Rockwell service letter

Service Letter No. SL-AG-28
September 12, 1963

TAILWHEEL TRUNNION ATTACH SHAFT

ENGINEERING ORDER

NO. 5-5008 E

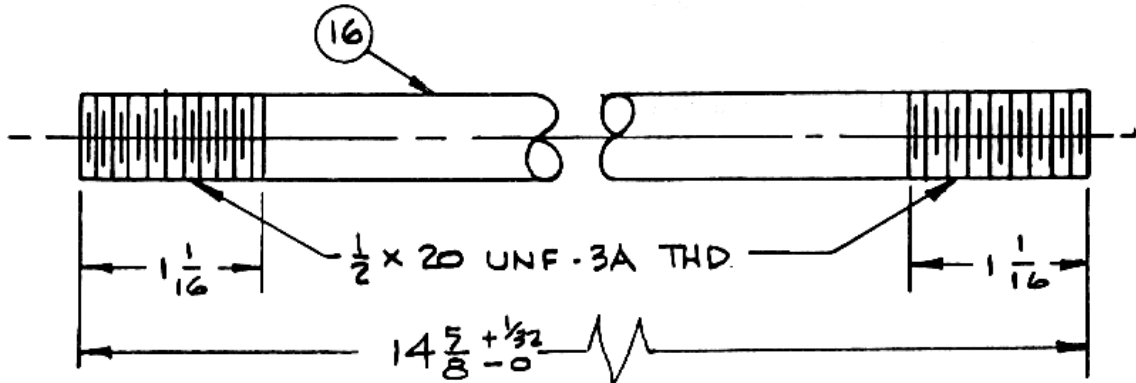
- (1) ADD A TRUNNION ATTACH SHAFT, P/N 5-5008-16 TO THE F/D AND B/M. MATL OF SHAFT IS 1/2" DIA ROD OF 303 STAINLESS STEEL, 1/4 HD.

- (2) DELETE P/N 5-5008-9.

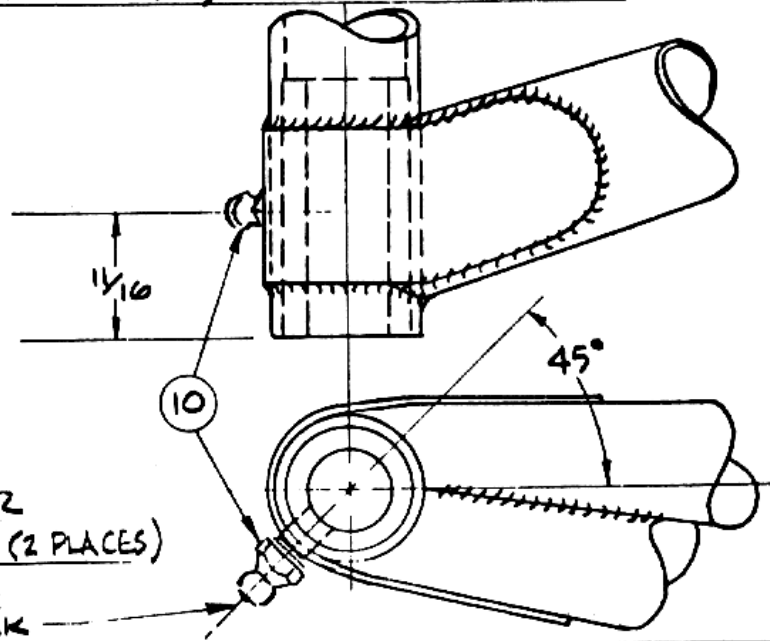
- (3) IN THE SIDE AND TOP VIEWS SHOW THE ZERK FITTINGS (ONE EACH SIDE) AS SHOWN BELOW.

DRILL #3 HOLE AFTER
INSTL OF BEARING (2 PLACES)
TAP 1/4 x 28 UNF-3B
AND INSTALL ZERK
